# Request for Continued Examination (RCE) Transmittal

| Application Number     | 10/798,693 |

## This is a Request for Continued Examination (RCE) under 37 CFR 1.114 of the above-identified application.

**RESPONSE TO OFFICE ACTION DATED JUNE 10, 2009**

FIG. 6

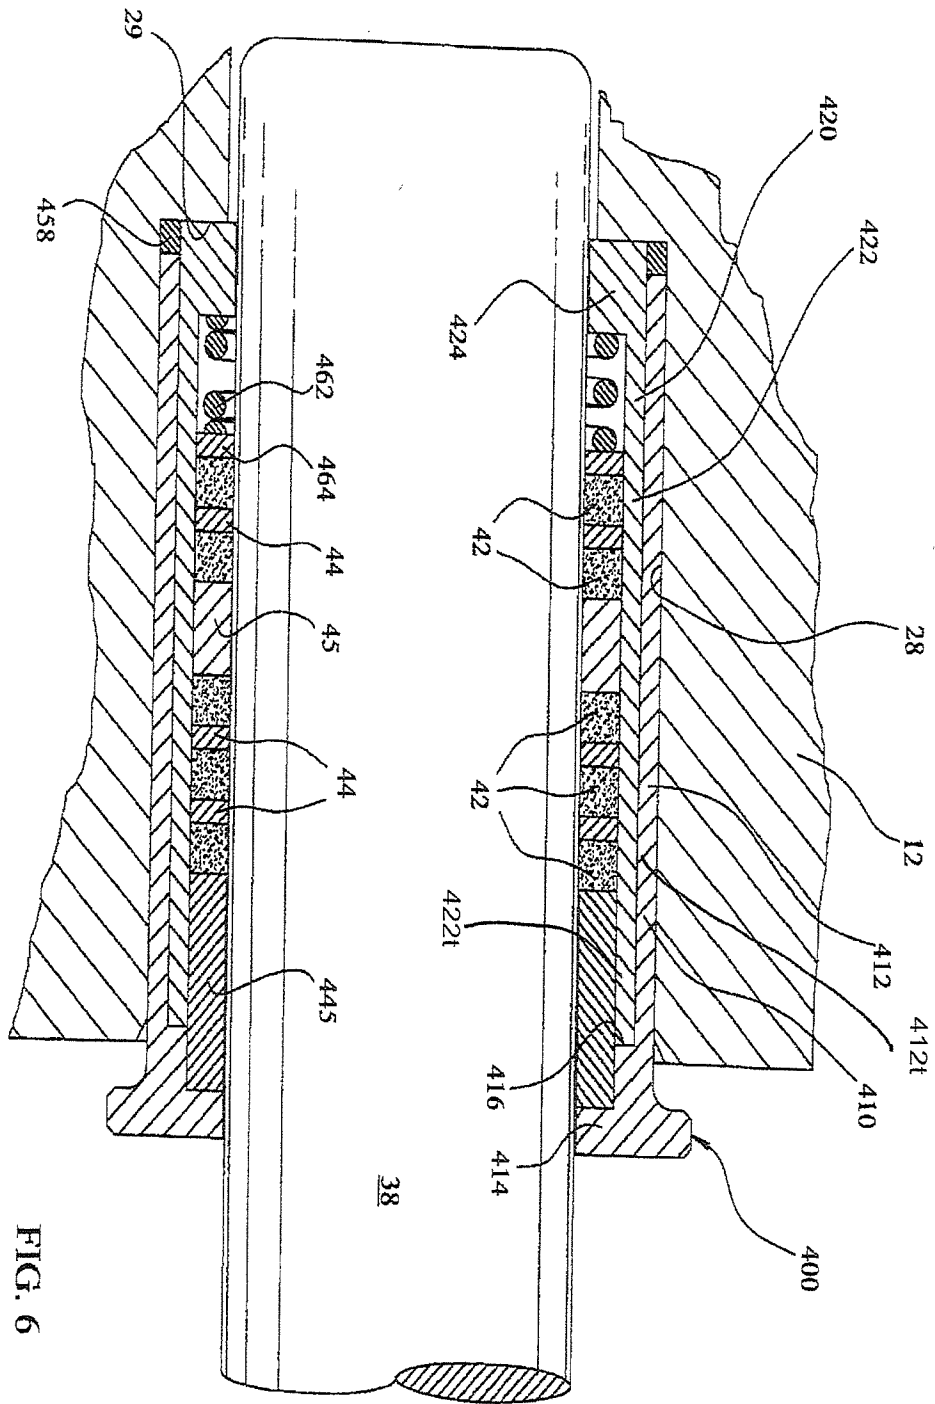
Regarding Figures 6 and 12, Paragraphs 0156 and 0158 of the specification are amended to include the specific references 412t and 422t for the “telescoping structures” and Figures 6 and 12 of the drawing is amended to include these references. Figure 12 is a cross-sectional view of another embodiment of a packing cartridge similar to the embodiment shown in Figure 7 (*See, e.g.*, Specification Paragraphs 0076 and 0193), where Figure 7 is a cross-sectional view of another embodiment of a packing cartridge similar to the embodiment shown in Figure 6 (*See, e.g.*, Specification Paragraphs 0068 and

[0156] Preferably, a spacer ring **445** is positioned operatively to cover the overlapping travel of the telescoping structures 422t and 412t between the first and second sleeve portions **410** and **420**. This spacer ring **445** helps prevent seepage of fluid into any clearances between the first sleeve portion **410** and the second sleeve portion **420**. The spacer ring **445** can also act as a back-up ring for the packing rings **42**.

[0158] As will be appreciated, the telescoping structures 422t and 412t of the first sleeve portion **412** and the second sleeve portion **422** allow for squeezing of the first abutment ring **414** and the second abutment ring **424** co-axially closer to one another after positioning the pre-assembled packing cartridge **400** on a plunger **38** in the packing bore **28**. However, in this embodiment, the packing cartridge **400** is positioned in the packing bore **28** and tightened by a gland nut (not shown) until the second sleeve portion **422** bottoms out against a shoulder **416** of the first sleeve portion **412**. In this position, the coil spring **462** is compressed with a packing assembly positioned between the first abutment ring **414** and a second abutment ring **424**. The advantage of bottoming out the telescoping structures 422t and 412t is that it prevents over-tightening of the packing cartridge **400** in the packing bore **28**. The spring **462** maintains a pre-determined amount of axial compression on the packing rings **42** of the packing stack.
